From: [Katriona Kinsella](#)
To: [DPTI:Planning Engagement](#)
Subject: Submission - Draft Planning and Design Code
Date: Monday, 2 March 2020 8:50:30 AM
Attachments: [Submission - Draft Planning and Design Code Phase Three - Katriona Kinsella.pdf](#)

Re: State Planning Reform - Draft Planning and Design Code Phase Three (Urban Areas)

DTS/DPF 3.1 Where constituting affordable housing, the minimum site area specified for a dwelling can be reduced by up to 20%.

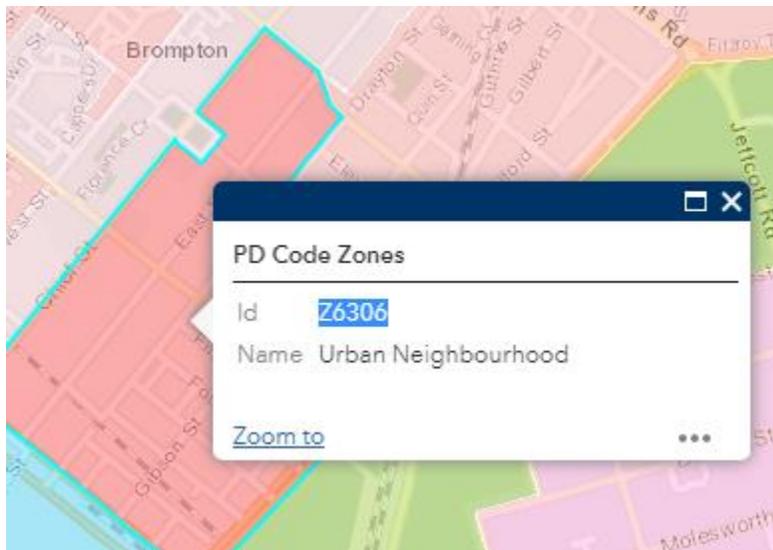
1 b. For similar reasons above, based on discriminatory parameters for those only able to afford affordable housing options, I also do not support the policy that would allow for the decrease of minimum site areas of up to 20%. Again, affordable housing should not constitute a decrease on minimum standards and quality of living. I therefore refute the inclusion of:
